# UNITED STATES PATENT AND TRADEMARK OFFICE

APPLICATION NO.	FILING DATE	FIRST NAMED INVENTOR	ATTORNEY DOCKET NO.	CONFIRMATION NO.
08/736,896	10/25/1996	CHRISTOPHER G.M. KEN	290252016600	4538

**Office Action Summary**

## DETAILED ACTION

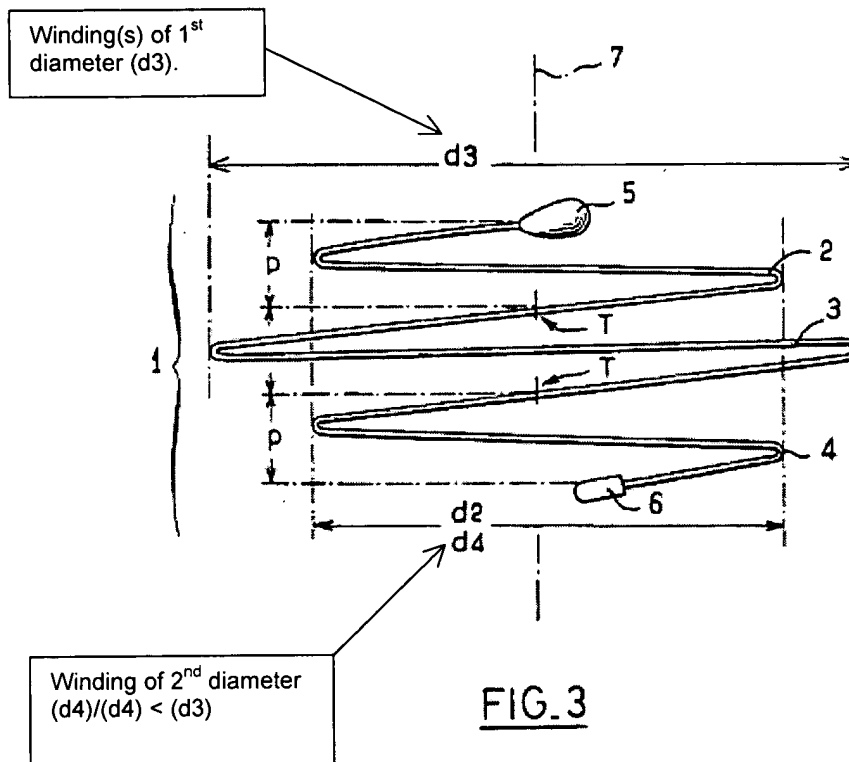
As to claims 1, 3-4, 6-10, and 12-15 DIBIE (Figs. 1-3, 5-6 and 9; column 8, lines 25-28) discloses a flexible helical coil (1) for use with a wire/cable (19). The coil has a distal end (5) and a proximal end/a second coupling member (6) detachably coupled/interlocked to the distal end/the 1<sup>st</sup> coupling member (18) of wire/cable (19) (Fig. 9). The coil comprises one winding (3) (shown in Figs. 2-3) or a multiplicity of windings (3) (not shown, but DIBIE discloses in column 8, lines 25-28 that the device can have a number of windings of more or less than three windings) of a 1<sup>st</sup> diameter (d3) immediately adjacent of the distal end (5) and the proximal end (6) of the coil. The coil further is wound into a 2<sup>nd</sup> diameter (d2)/(d4) smaller than the 1<sup>st</sup> diameter (d3) of about 27mm (column 7, lines 14-15 and Fig. 3), whereby the proximal end (6)/the 1<sup>st</sup> coupling member and the distal end (5) of the coil are positioned radially inwardly of the immediately adjacent 1<sup>st</sup> diameter (d3) as shown in Fig. 2.

Alternatively, DIBIE does not explicitly show a multiplicity of windings (3) of the 1<sup>st</sup> diameter (d3) in the drawings, however, according to the disclosure (column 8, lines 25-28), it would have been obvious to one of ordinary skill in the art to have a multiplicity of windings (3) such as two or three windings (3) as this configuration would be well within the scope of DIBIE's invention.
